03PL096

Internal water and sewer 8" minimum. (6" min. water in cul de sacs with approved design)
REFERENCE:
SOUTH TRUCK ROUTE DRAINAGE BASIN PLAN
5th STREET DESIGN PLANS
UTILITY MASTER PLANS (REV.)
PRELIMINARY: NOT FOR CONSTRUCTION
LAYOUT PLAT
REVIEWED BY CITY ENGINEERING DIVISION
COMMENTS
Contractors shall be responsible for obtaining all necessary permits from the City Engineering Division before starting any of the proposed public improvements.

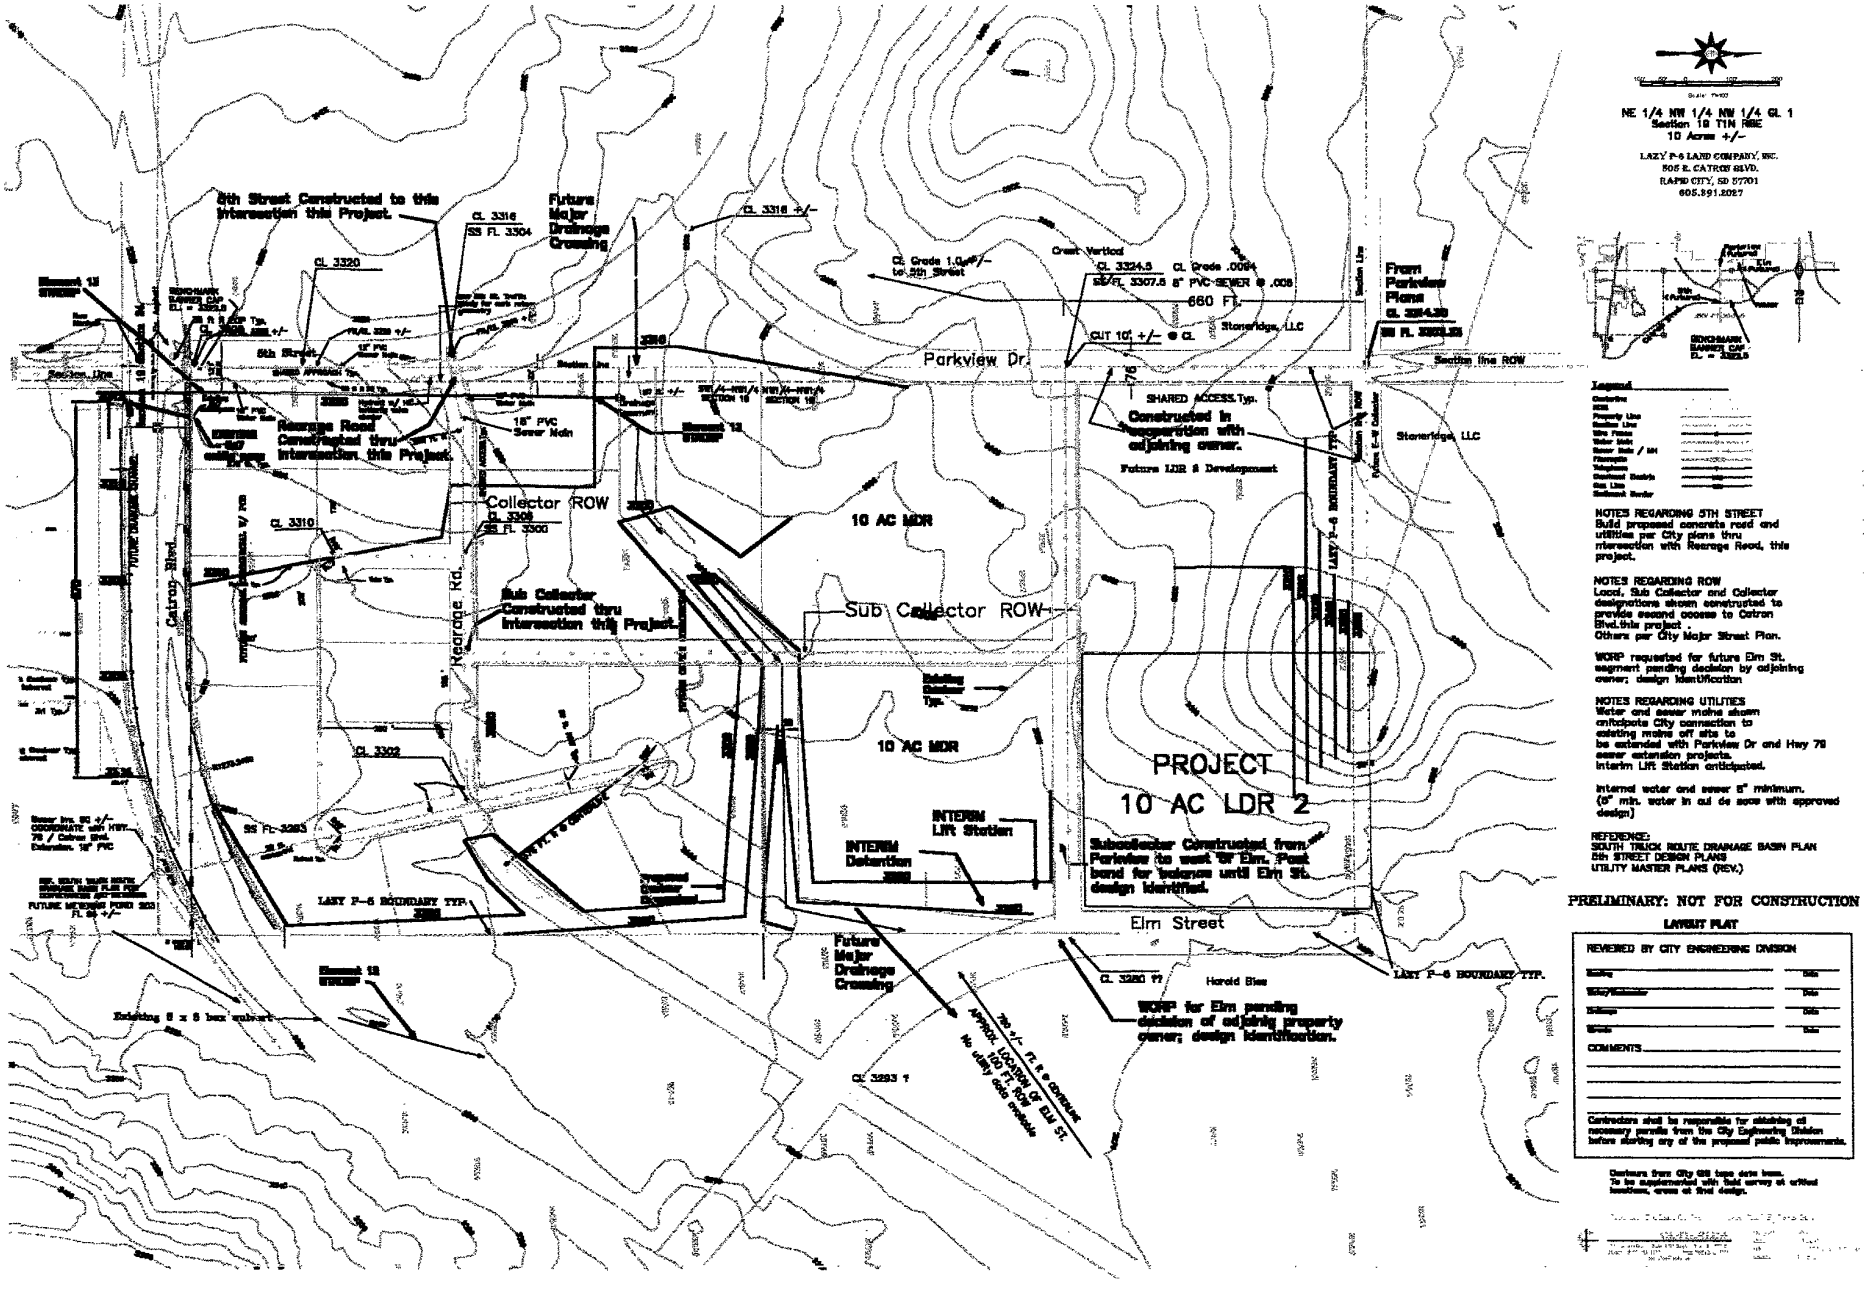
NE 1/4 NW 1/4 NW 1/4 GL 1
Section 19 T1N R6E
10 Acres +/-
LAZY P-6 LAND COMPANY, INC.
505 E. CATRON BLVD.
RAPID CITY, SD 57701
605.391.2027
5th Street Constructed to this Intersection this Project.
Future Major Drainage Crossing
CL 3316
SS FL 3304
CL 3320
CL 3316 +/-
Crest Vertical
CL 3324.5
SS FL 3307.5
CL Grade .0094
8" PVC SEWER @ .008
660 FT.
CUT 10' +/- @ CL
Stoneridge, LLC
From Parkview Plans
Parkview Dr.
Section line ROW
SHARED ACCESS Typ.
Constructed in cooperation with adjoining owner.
Future LDR 2 Development
Stoneridge, LLC
Rearage Road Constructed thru Intersection this Project.
18" PVC Sewer Main
Collector ROW
CL 3308
SS FL 3300
CL 3310
10 AC MDR
Catron Blvd.
Rearage Rd.
Sub Collector Constructed thru Intersection this Project.
Sub Collector ROW
Existing Culvert Typ.
10 AC MDR
PROJECT
10 AC LDR 2
CL 3302
SS FL 3293
INTERIM Lift Station
INTERIM Detention
Subcollector Constructed from Parkview to west of Elm. Post bond for balance until Elm St. design identified.

LAZY P-6 BOUNDARY TYP.
Elm Street
Future Major Drainage Crossing
CL 3280 ??
Harold Bise
LAZY P-6 BOUNDARY TYP.
WORP for Elm pending decision of adjoinig property owner; design identification.
Existing 8 x 8 box culvert
CL 3293 ?
APPROX. LOCATION OF ELM ST. 100 FT. ROW No utility data available
Legend
NOTES REGARDING 5TH STREET
Build proposed concrete road and utilities per City plans thru ntersection with Rearage Road, this project.
NOTES REGARDING ROW
Local, Sub Collector and Collector designations shown constructed to provide second access to Catron Blvd.this project .
Others per City Major Street Plan.
WORP requested for future Elm St. segment pending decision by adjoining owner; design identification
NOTES REGARDING UTILITIES
Water and sewer mains shown anticipate City connection to existing mains off site to be extended with Parkview Dr and Hwy 79 sewer extension projects.
Interim Lift Station anticipated.
